**Comment Summary – November 21, 2024 (4<sup>th</sup> Submission)**  
**Zoning By-law Amendment Application – WDD Main St. Inc.**

**Re: Zoning By-Law Amendment 4th Submission  
11 Main Street (Morrison)  
Puslinch, ON**

**RE:** Hydrogeological Review Comments – 4<sup>th</sup> Submission  
WDD Main Street Inc. – 11 Main Street, Morriston (Puslinch), Ontario  
Proposed Residential Subdivision  
Zoning By-law Amendment / Draft Plan of Subdivision Application

# Post-Development Uncontrolled Visual-Oththymo Schematic

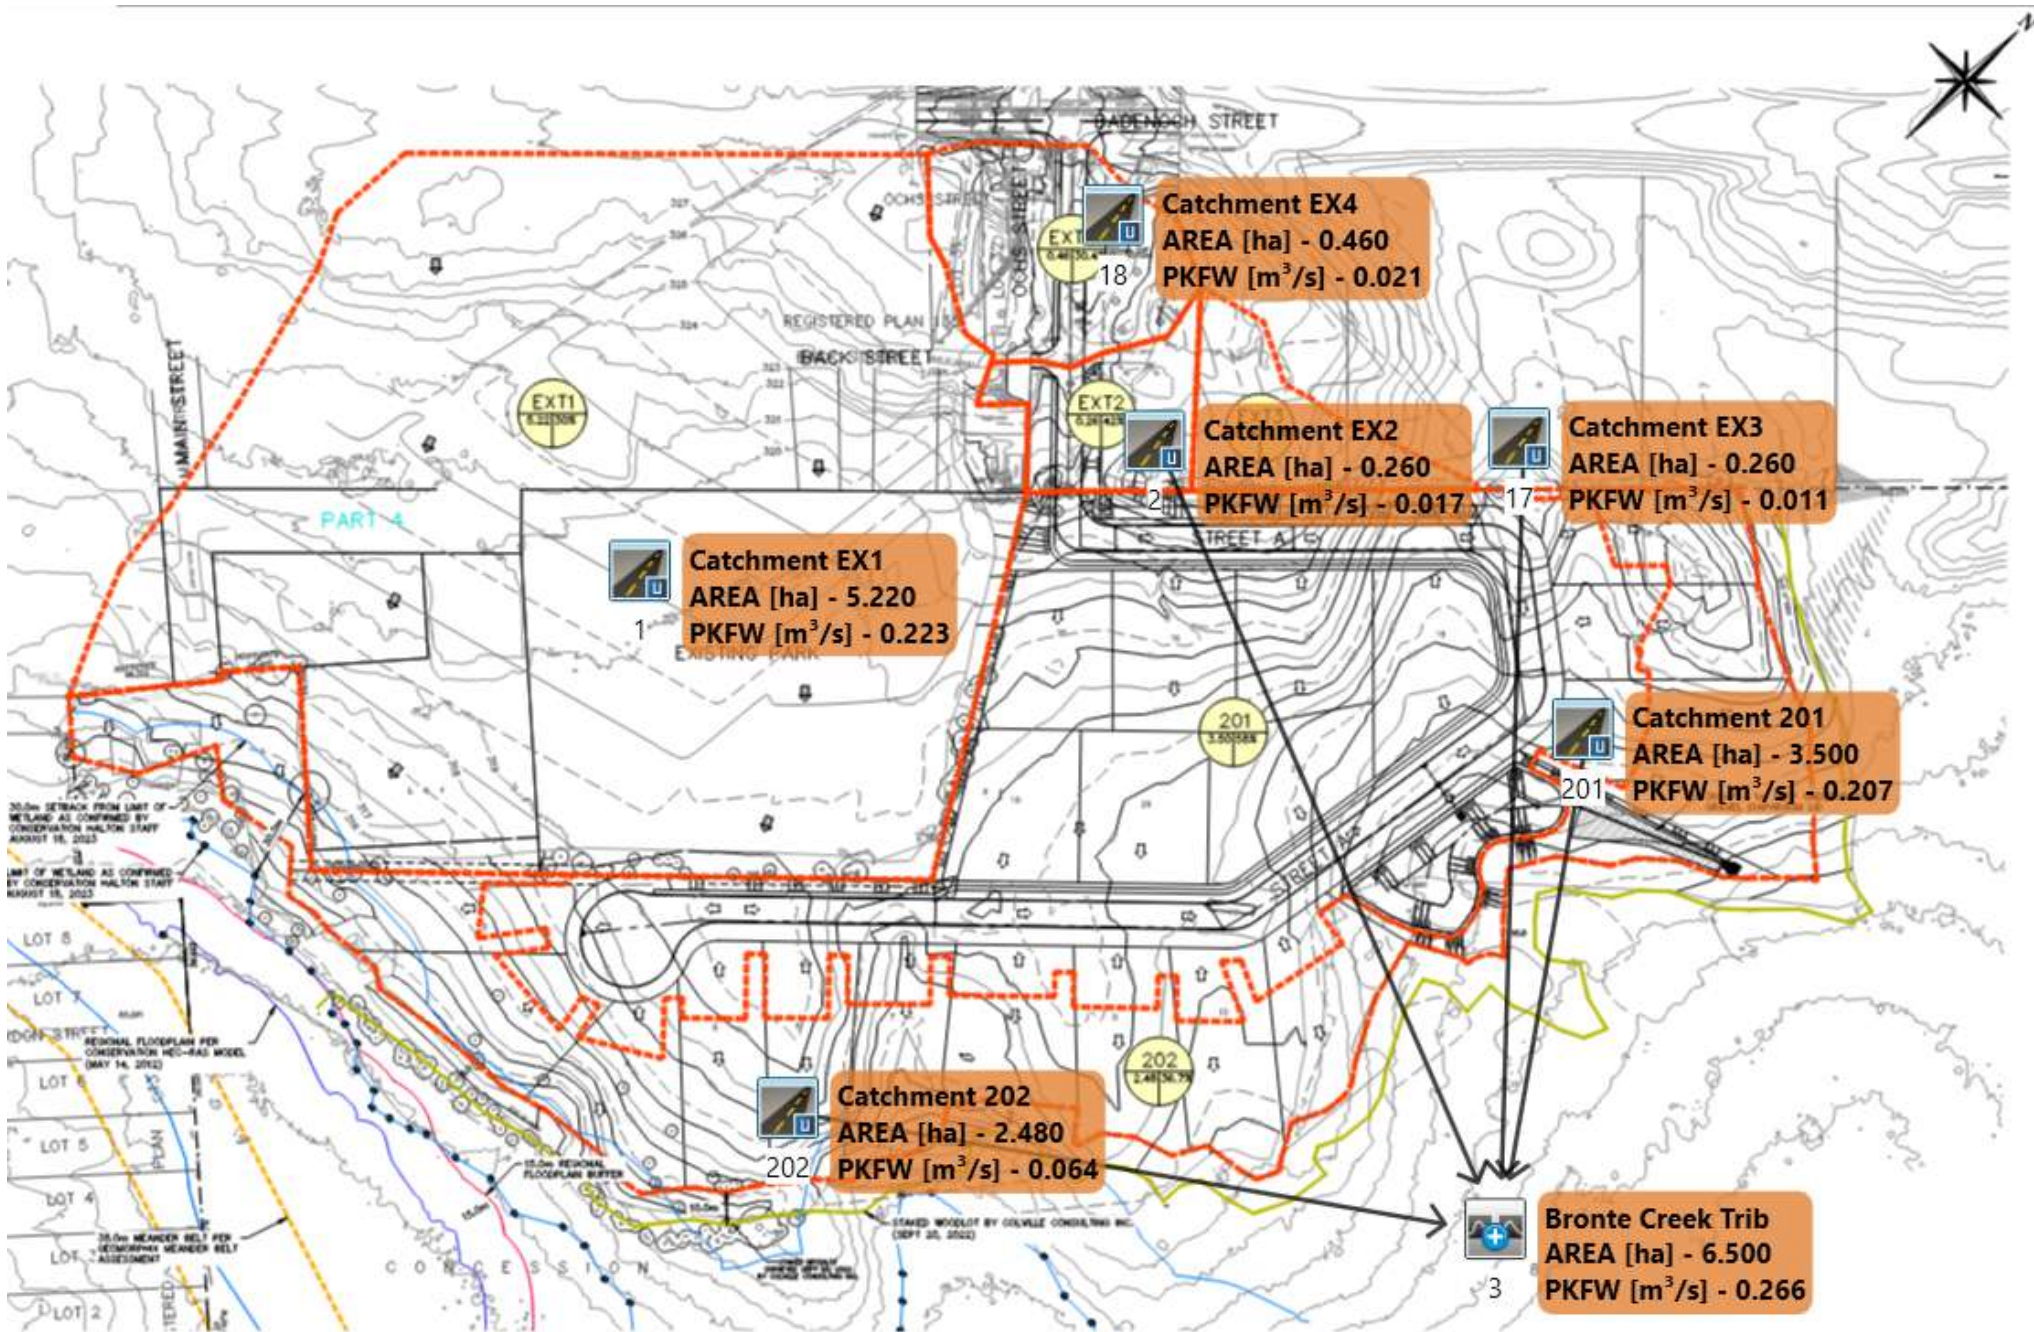
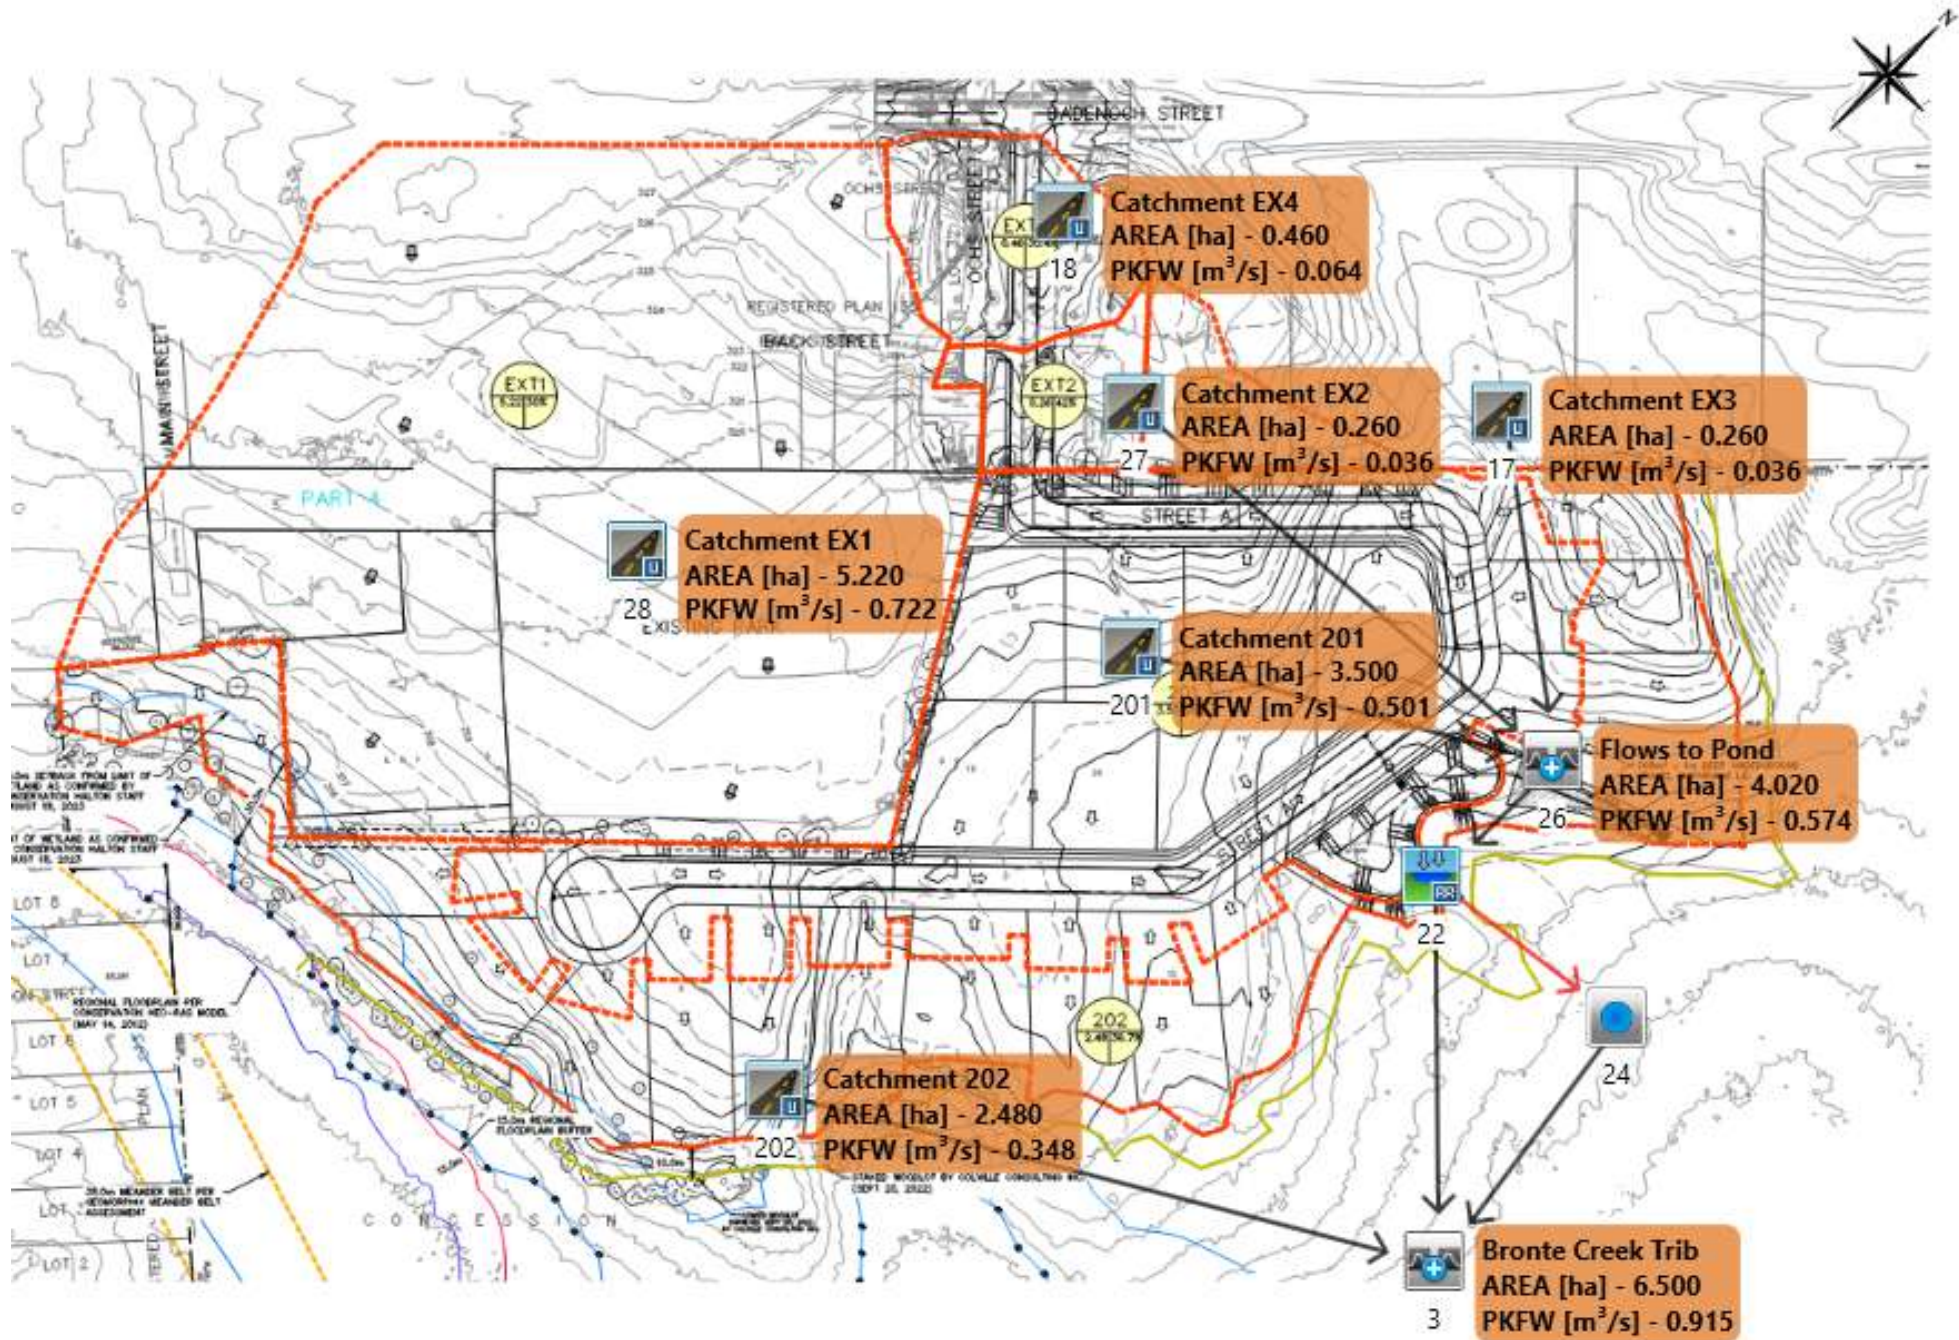
No.	Matter	Document	Date Identified	Comment
12.	Stormwater Model – Visual OTTHYMO	FSR – VO Schematics	April 20, 2023	<p><u>GEI Comment (April 20, 2023)</u>                      Please replace the wording of the “Post-Development” schematic title to reflect a post-development uncontrolled scenario.</p> <p>Please replace the wording of the “Post-Development w/ Mitigation” to be “Post Development Controlled”. This will make it consistent with Table 8 in the report and will make ultimate conditions clear.</p> <p><u>Crozier Response (January 2024)</u>                      The Visual OTTHYMO and schematics has been updated to reflected Table 8.</p> <p><u>GEI Comment (February 9, 2024)</u>                      Accepted, no further comment.</p>
